# Instrument Engineering Change Notice

NO. Prisma Plus-2001

PRODUCT NAME	: Tissue-Tek Prisma Plus	DATE	: March 18, 2020
PRODUCT CODES	: 6170, 6171, 6172, 6173, 6174, 6175, 6177	ORIGINATOR	: A. Ito, T. Iijima
IECN TYPE	: SOFTWARE CHANGE AND PART DESIGN CHANGE	REFERENCE NUMBER	: 16828-1, 16827-1, 16803, 16720
SERIAL NUMBERS AFFECTED	: See Remarks	ATTACHMENTS	: A-SK25-0900-05-A.zip
FIELD RETROFIT REQUIRED	: NO

## Title: Software and Hardware Changes for New CI

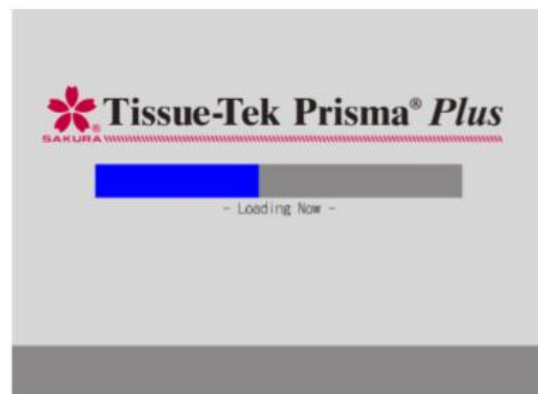
- (1) The logo displayed at the top left corner of each operation screen was deleted due to the change to the new CI logo.

The loading screen was also changed with the change of the initial program loader, as follows:

New loading screen (white background)

Old loading screen

New operation screen

Old operation screen
